The clock is ticking until the next flood, and after 25 years and million spent on engineering consultants we still do not even have plans for the construction of a South Boulder Creek flood mitigation facility.

In 1996, a floodplain study determined hundreds of homes were constructed in the 100-year floodplain of South Boulder Creek and that a flood control project was needed to prevent the loss of lives and property.

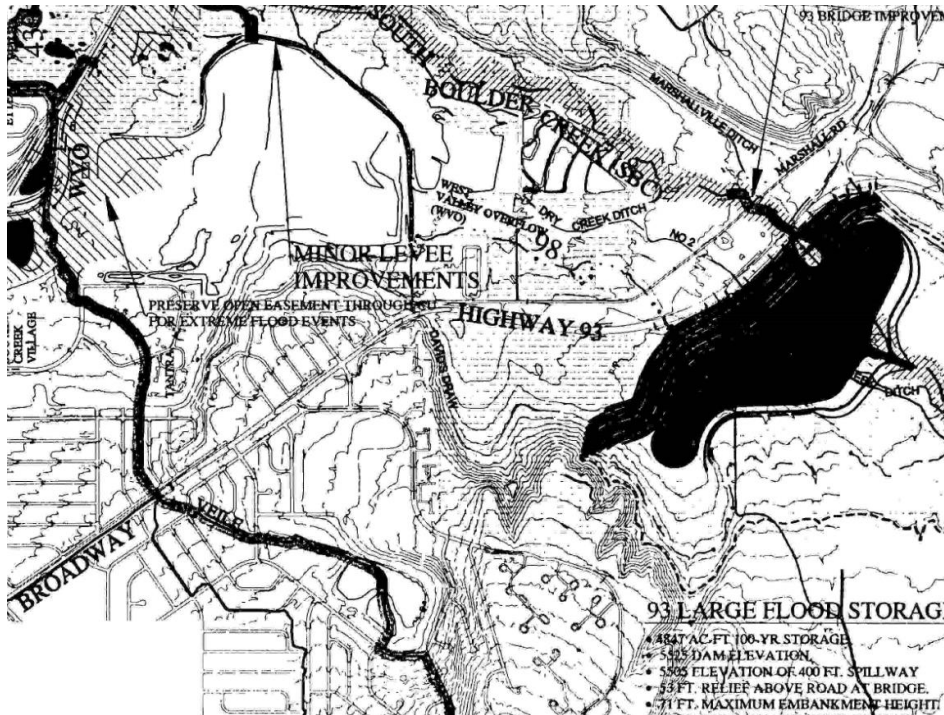
In 2000, a \$140,000 Taggart Engineering Associates South Boulder Creek drainage study recommended a 1,107 Acre Feet detention pond upstream of US 36 to protect residents against a 100-year flood. The detention pond is in approximately the same location as the current plan. The current detention pond is 469 acre feet, less than half the size of the original plan.

Stormwater Detention Upstream of US36
South Boulder Creek Flood Mitigation Project

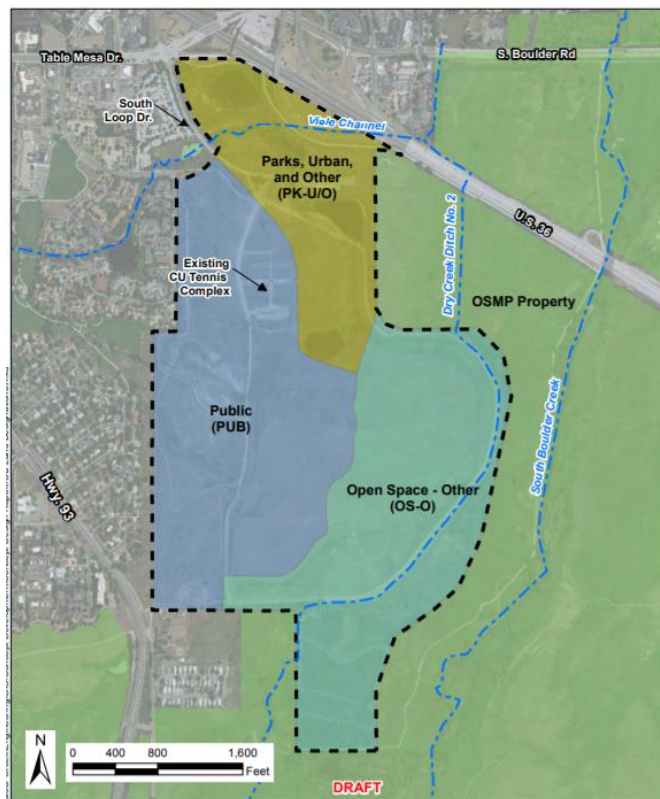
- Viele Channel dead-ended into the upstream side of the dam providing no place for the water to go.
- The groundwater cutoff wall from the base of the dam/floodwall to bedrock along the entire length of the dam/floodwall from Table Mesa Drive up the hill to South Boulder Creek would completely block the westerly flow of groundwater causing groundwater to back up onto the abandoned CU South gravel pit and dry up State Natural Area grasslands on the other side of the highway.
- Without obtaining an easement from the Colorado Department of Transportation, the concrete floodwall along US 36 was located inside of the CDOT ROW.
- The excavated detention pond located below groundwater level would fill with groundwater and not be available to detain floodwaters.

Figure 8: Variant 2 500-year concept

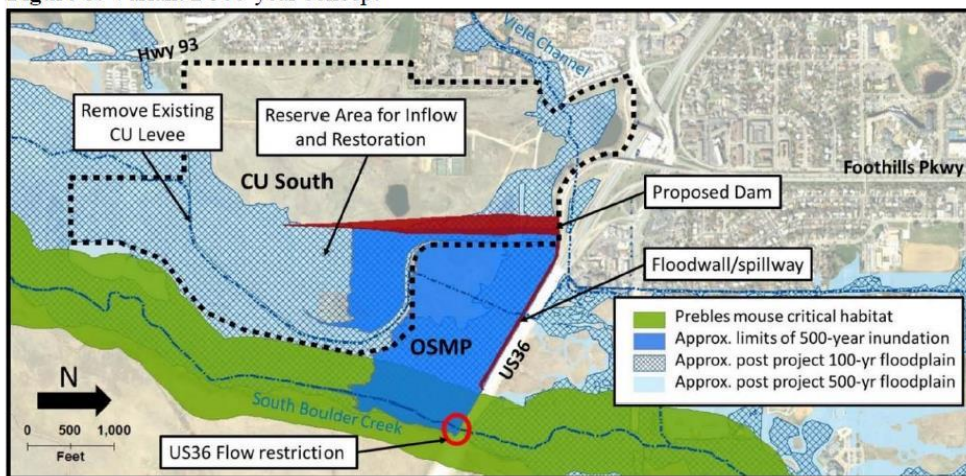
In 2018, the city's engineering staff, engineering consultant and the WRAB recommended the hazardous Variant II flood mitigation option which would severely constrict the size of the opening of the US 36 bridge over South Boulder Creek to the point there would be no freeboard to allow for the passage of floating debris.

That plan violated basic fundamental bridge design standards and was not in compliance with CDOT bridge design specifications; nonetheless the hazardous plan was CU's first choice as it primarily inundated City Open Space and not the CU South gravel pit.
